AMENDMENT OF SOLICITATION/MODIFICATION OF CONTRACT				1. CONTRACT ID CODE <div style="text-align: center;">J</div>		PAGE OF PAGES <div style="text-align: center;">1 7</div>

2. AMENDMENT/MODIFICATION NO. <div style="text-align: center;">0004</div>		3. EFFECTIVE DATE <div style="text-align: center;">18-Sep-2003</div>		4. REQUISITION/PURCHASE REQ. NO. <div style="text-align: center;">W16ROE-3217-9348</div>		5. PROJECT NO.(If applicable)

AMENDMENT 0004

NOTE:
STAIR TOWER #4 SIMILAR OPPOSITE HAND

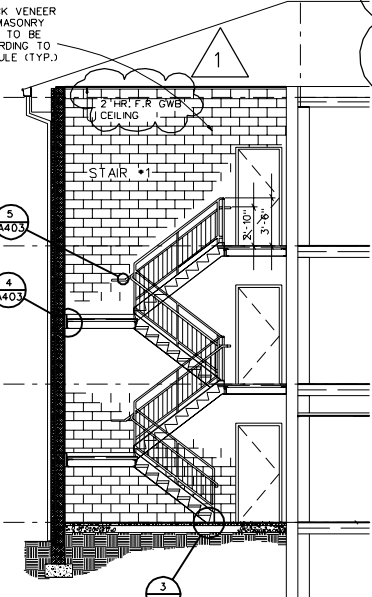
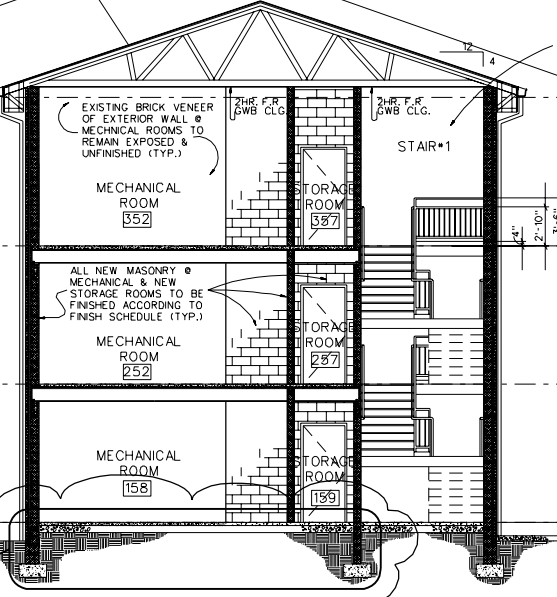
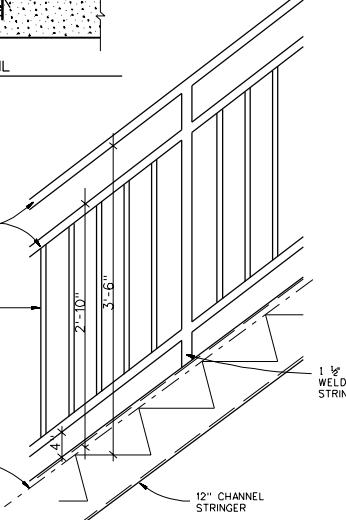
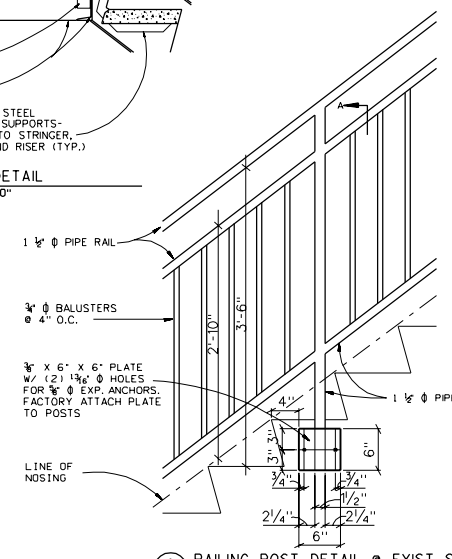
Question: Dwg. D-100 Demolition Note 10 calls for removing existing stair handrails and railings. Please provide details for new railings if contractor has to install new railings.

Response: Detail is provided on amended Drawing A403.

NOTE:
1. EXISTING STAIRS NOTED #2 & 3 SHALL HAVE ALL NOSINGS, ADHESIVES, HANDRAILS, ETC., REMOVED DOWN TO BARE CONCRETE. ALL HOLES, CRACKS, POCKMARKS, BLEMISHES, ETC., SHALL BE FLASH PATCHED WITH EPOXY CEMENT TO A SMOOTH FLAT SURFACE. INSTALL NEW SAFETY NOSING IN ACCORDANCE WITH SPECS. SECTION 05500, PARAGRAPH 2.12.
2. ALL WELDS SHALL BE GRIND SMOOTH AND ALL NEW HANDRAILS, RAILINGS, STRINGER, & UNDERSIDE OF STAIRS SHALL BE PAINTED TO MATCH NEW DOORS & STAIRS.
